INDIANA UTILITY REGULATORY COMMISSION

CAUSE NO. 45342

REDACTED SUPPLEMENTAL TESTIMONY

JAMES T. PARKS – PUBLIC'S EXHIBIT NO. 3

Figure 1. Current Water Treatment/Storage/Pumping Schematic

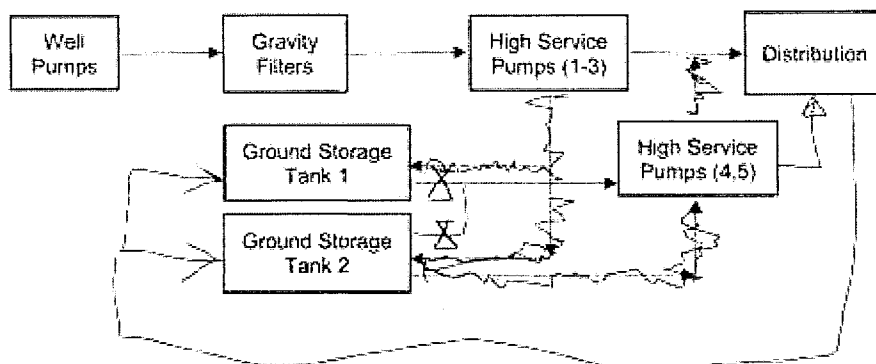
The existing condition flow paths are not accurate. The actual situation is like this. The GSTs float off the distribution system. The blue valves, as shown, allow each tank to be isolated before the tee connection.
